ENCLOSURE 6

QUALITY ASSURANCE PLAN DESCRIPTION

(CHANGES)

Quality Assurance Program Description (QAPD)

ENCLOSURE 1 – SHINE FUNCTIONAL ORGANIZATIONAL CHART

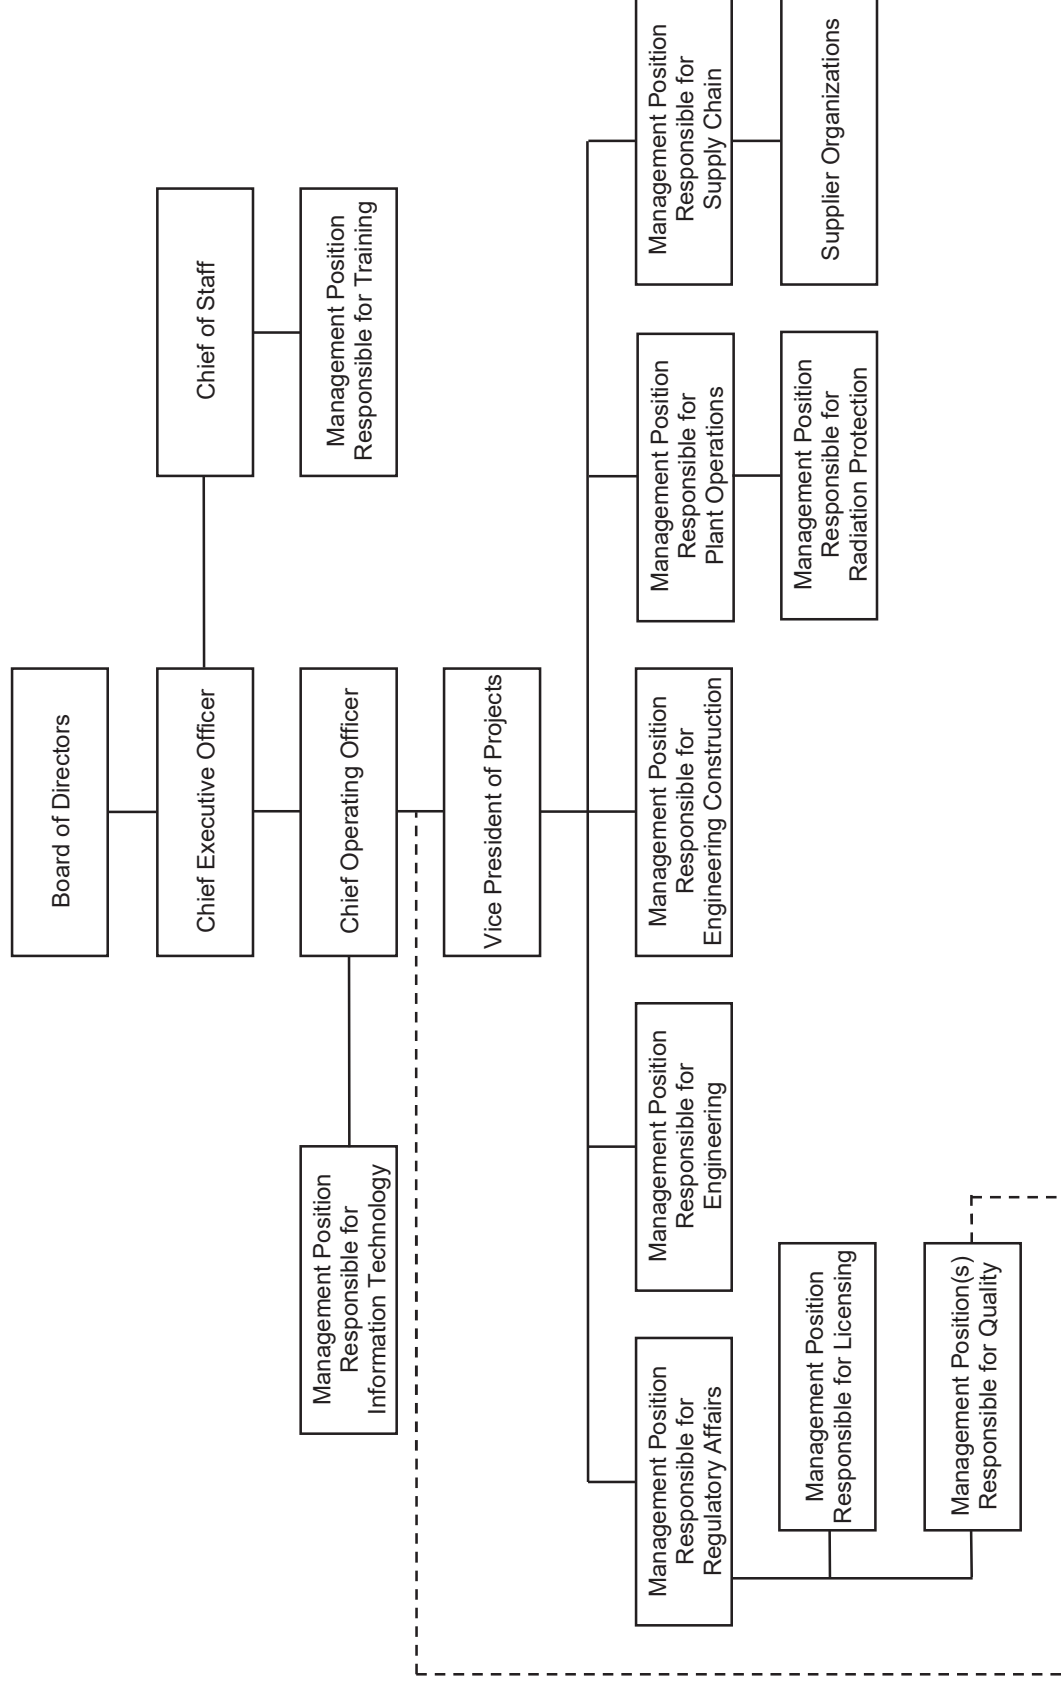
20	Revised to reflect organizational changes in Section 2.1, “Organization,” and Enclosure 1, “SHINE Functional Organizational Chart.” Revised Enclosure 3, “Procedures that Implement the QAPD,” to update the procedure numbers and titles of the SHINE Implementing Procedures and to remove Baker Implementing Procedures.
